HISTORIC AND DESIGN REVIEW COMMISSION

May 18, 2016

HDRC CASE NO: 2016-154
ADDRESS: 211 DEVINE ST
LEGAL DESCRIPTION: NCB 724 BLK 6 LOT 11
ZONING: RM4 H
CITY COUNCIL DIST.: 1
DISTRICT: Lavaca Historic District
APPLICANT: Emily & David Tucker
OWNER: Emily & David Tucker
TYPE OF WORK: Conceptual approval of a rear addition
REQUEST:

DEMOLITION PLAN

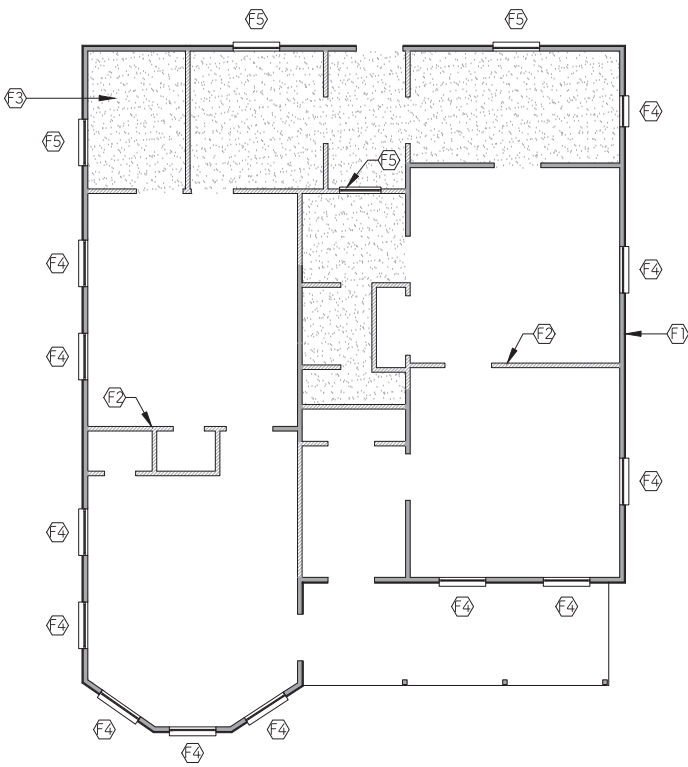
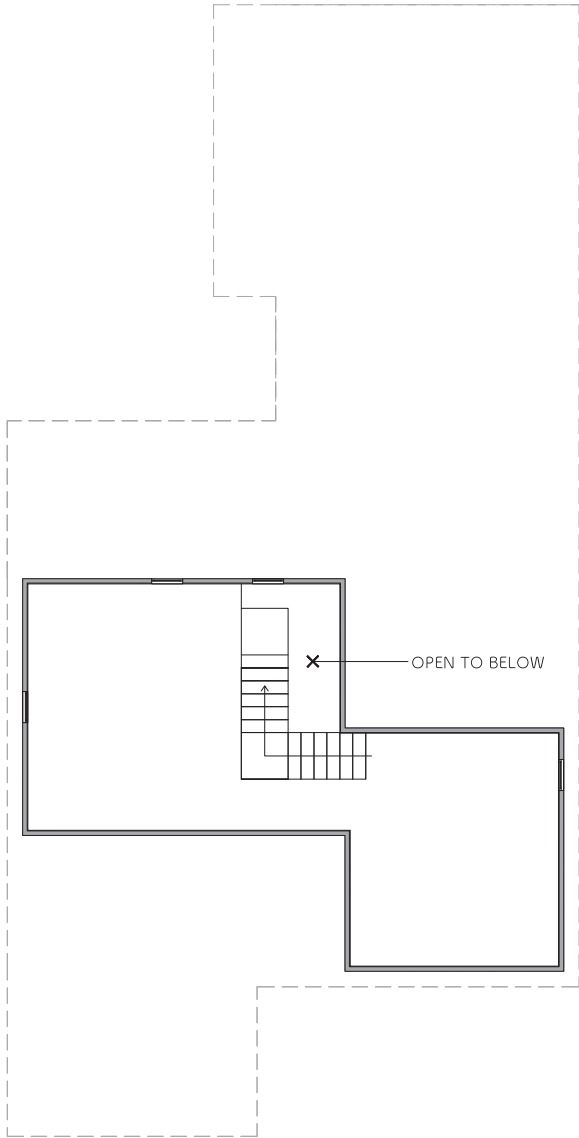
- c. Based on photos submitted, the addition will necessitate the removal of at least one original window. This window should be salvaged and reused consistent with the Guidelines for Additions 3.C.i.

1. That a furring strip or transition piece between the original house and the addition be incorporated onto the east elevation based on finding b;
2. That the existing rear window be salvaged and incorporated into the addition based on finding c.
3. That the applicant provide specifications for the proposed windows and trim that illustrates conformance with the windows policy document based on finding d.

ELEVATIONS

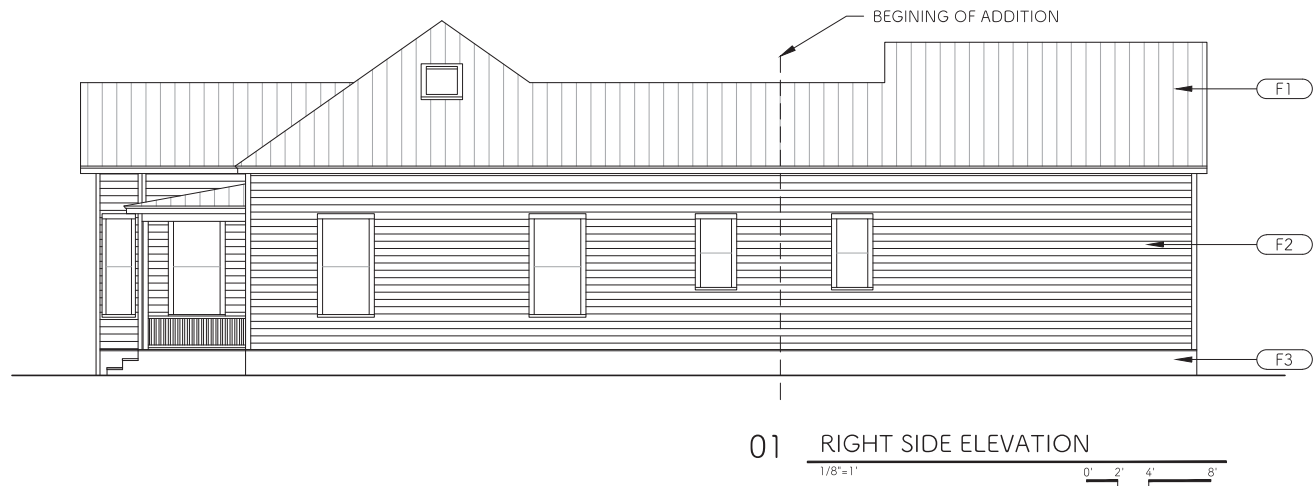
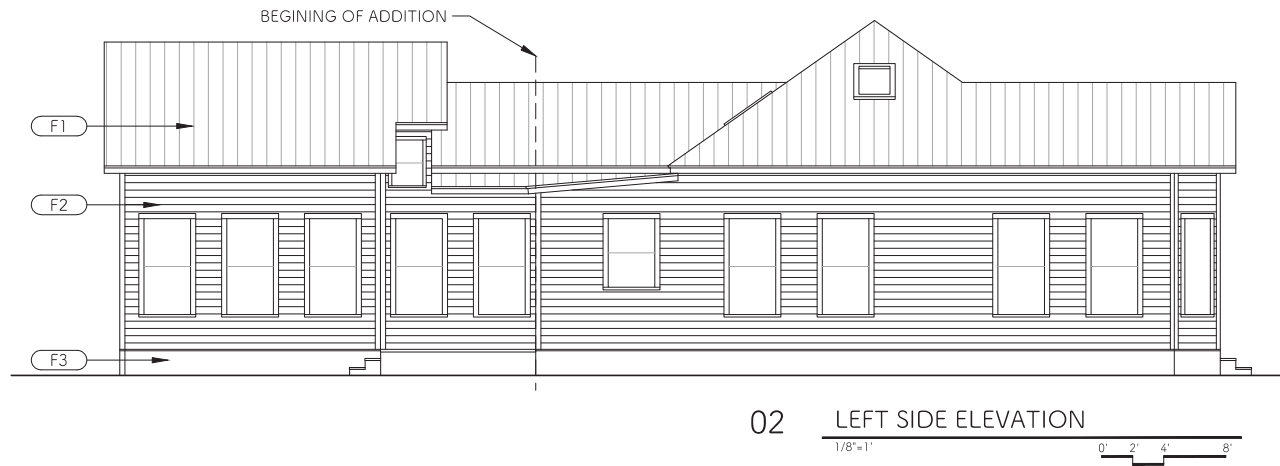
- b. The proposed addition will incorporate existing materials found on the historic house. This is consistent with the Guidelines for Additions 3.A.i. However, incorporating a furring strip or transition piece between the original house and the addition would be more appropriate and consistent with the Guidelines for Additions 1.a.iv.
